GULF STATES UTILITIES COMPANY

River Bend Station - Unit 1
Docket No. 50-458

TURBINE OVERSPEED PROTECTION SYSTEM
(91-01)

4.3.8.2.a.3

FIGURE 1

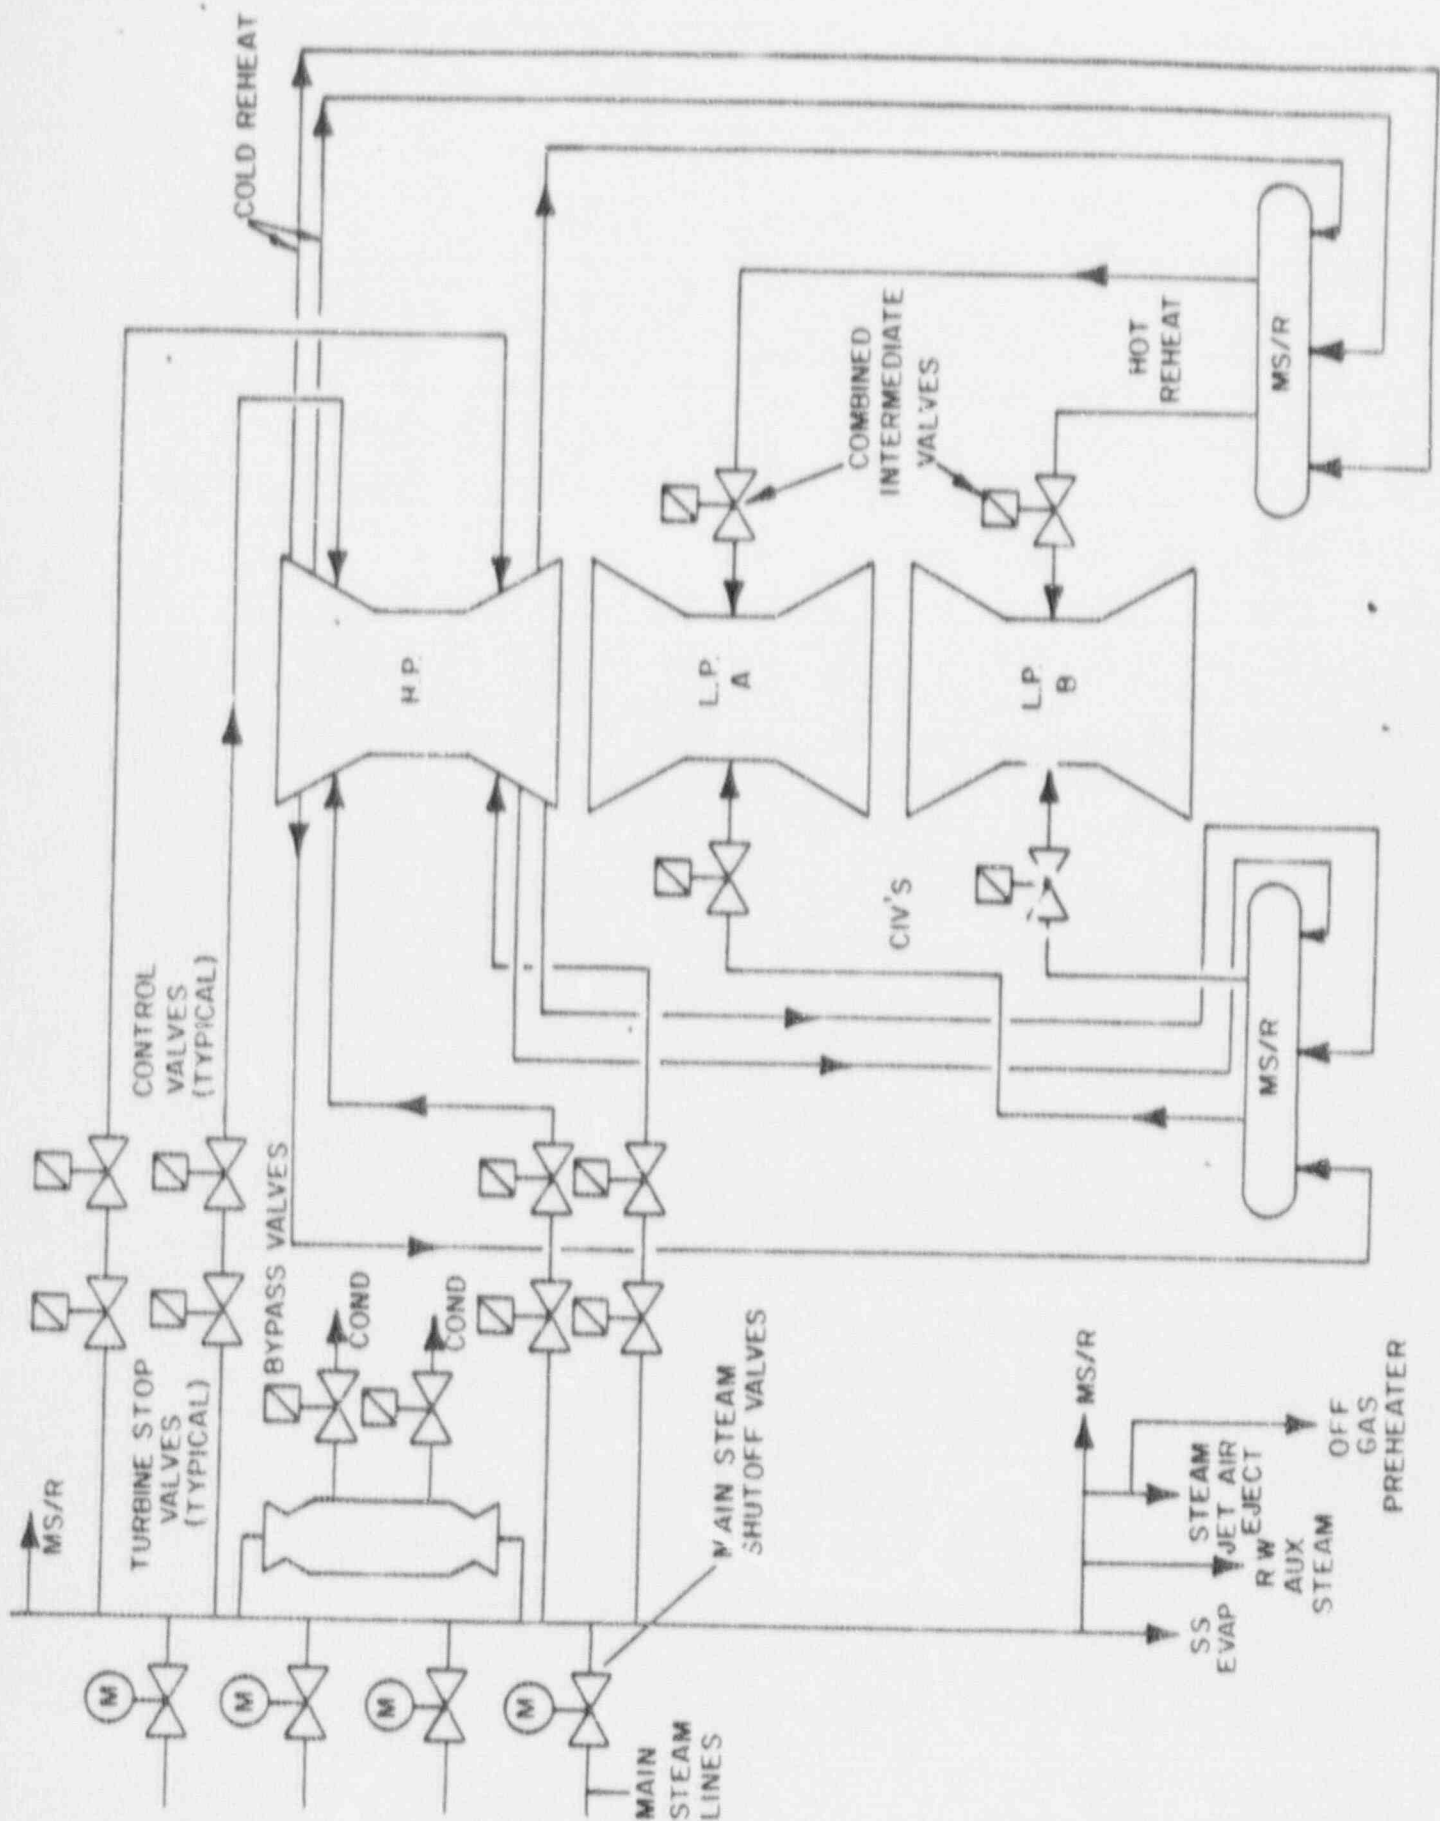
Figure 1 provides a simplified drawing to show that the main steam flows from the four main steam lines into an equalizing header (to equalize main steam line flow), through the four Turbine Stop Valves (TSV), through the four Turbine Control Valves (TCV) and enters the center of the high pressure turbine casing. Each TCV regulates the steam flow to one of the four nozzle boxes, two in the upper half shell and two in the lower half shell. The uniform flow distribution and the relatively thin walls of the nozzle boxes produce uniform heating of the shells to reduce distribution and minimize turbine shaft vibration.

FIG. 2

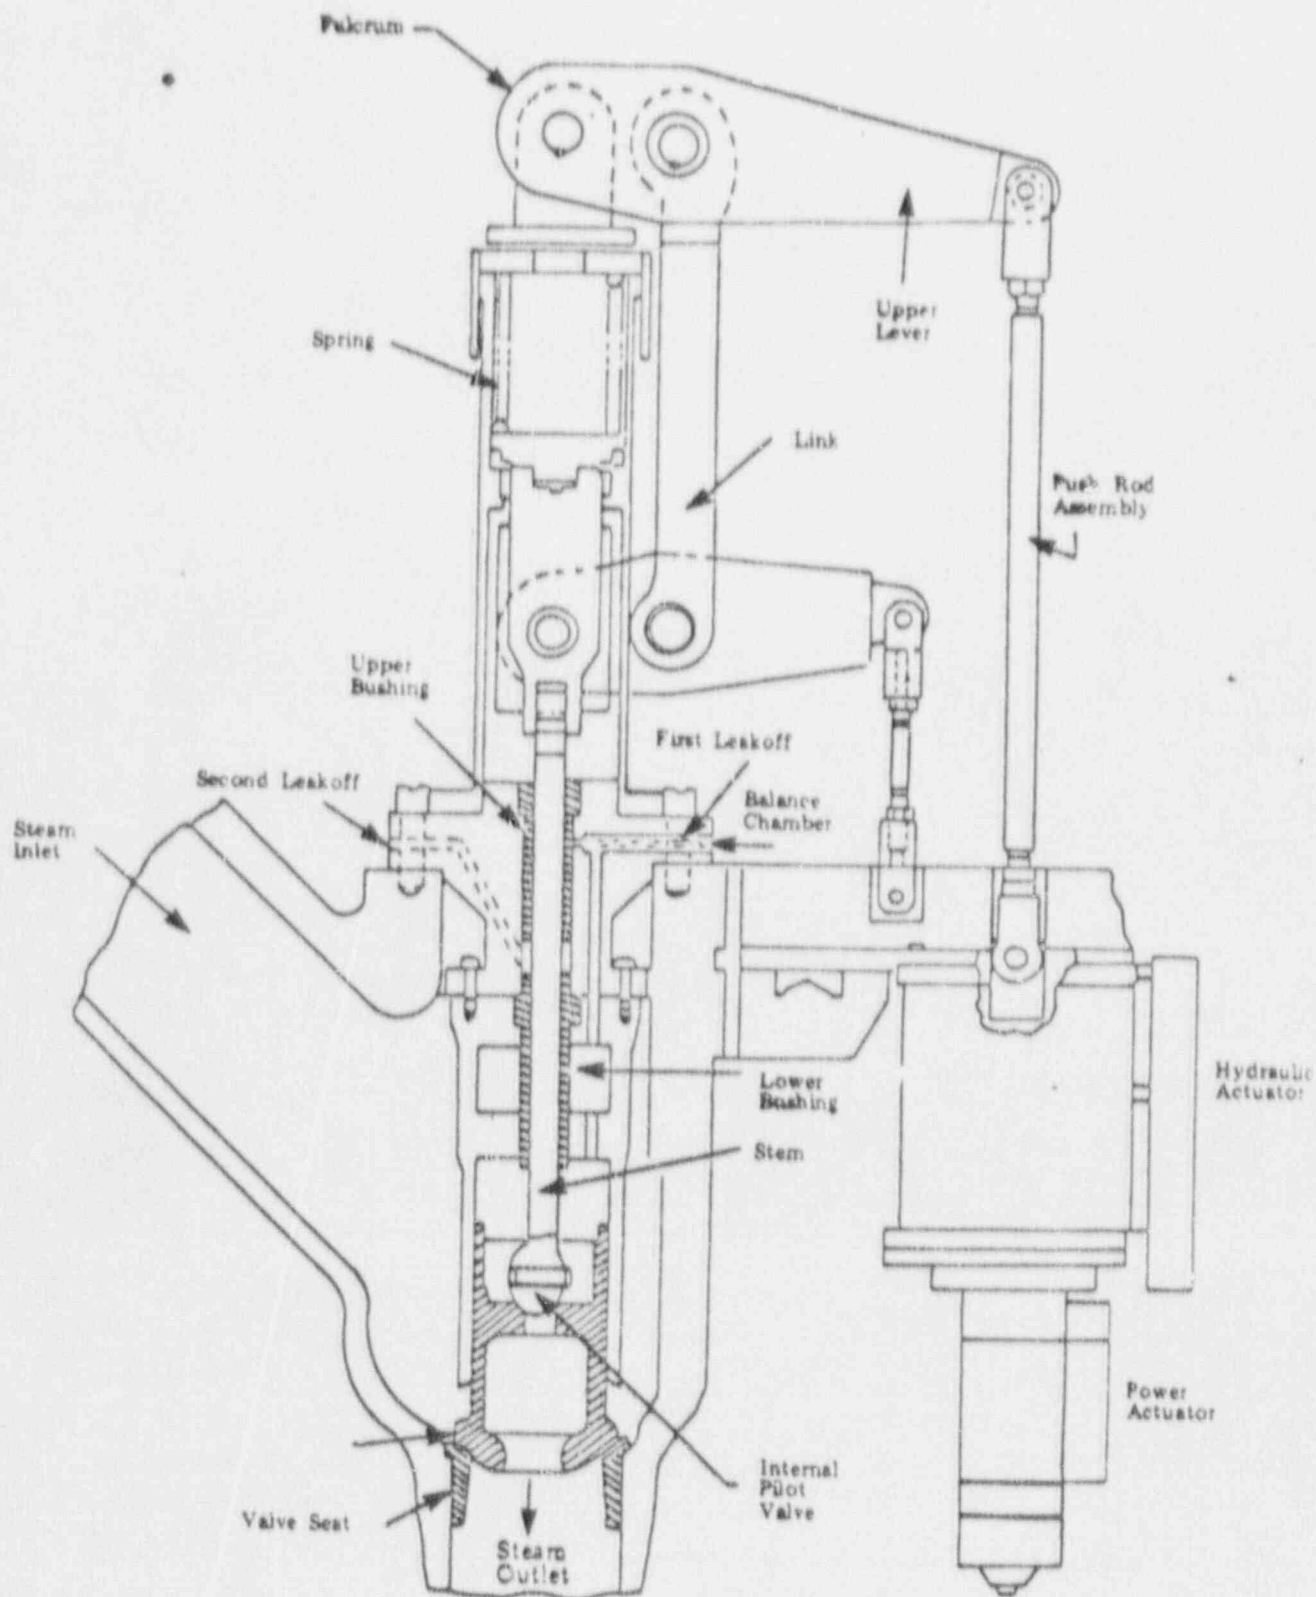
The control valves (Figure 2) are balanced piston valves, reducing the forces required to lift the valve disc. Each control valve is operated by a single acting spring-to-close servomotor. It is opened by a servo-valve that receives its signal from the Electro-Hydraulic Control (EHC) System. This servomotor and servo-valve control arrangement comprises the power actuator of each valve.
